## MEMORANDUM

**TO:** District of Columbia Zoning Commission

**SUBJECT: Hearing Report - ZC # 15-20 (Sursum Corda)**  
First Stage PUD and Related Map Amendment

Map 5 - Proposed Site Plan

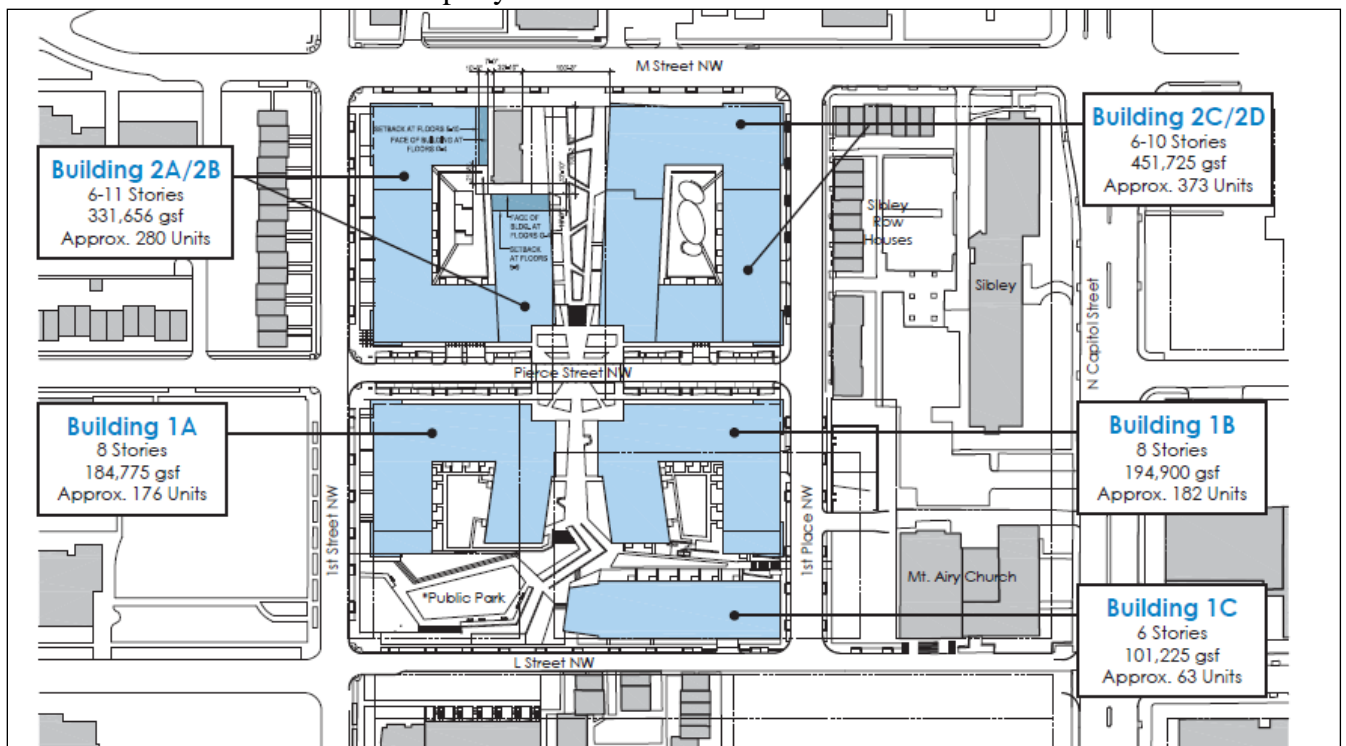
Subsequent to setdown, the Applicant has reduced the number of parking spaces from 848 to 786 spaces across the site which is 439 spaces above the 347 spaces required. Applicant was encouraged to reduce the number of spaces even further but states that the neighborhood has encouraged them to provide as many spaces as possible to counter the lack of parking in the area. The plans indicate that the parking spaces would be provided below grade in three levels that would be shared amongst all the uses on the property.

The parking/loading facilities would be consolidated to serve the buildings. Although the entrances seem to have been slightly reconfigured, the buildings would have five separate entrances, two to serve Buildings 1A, 1B and 1C and three to serve Buildings 2A/2B and 2C/2D (Exhibit 28A1, pages A-19, A-19, and A-20). The parking entrance for Buildings 1A, 1B and 1C would be off L and 1<sup>st</sup> Street, N.W. while the loading entrance would be off L Street, N.W. Buildings 2A/2B and 2C/2D would have two loading entrances and a parking entrance along Pierce Street, N.W and a second parking entrance along 1<sup>st</sup> Pace, N.W. accessed off Pierce Street while Buildings 1B and 1C would be accessed off L Street and First Place. Additional on-street parking would be accommodated on the adjacent streets.
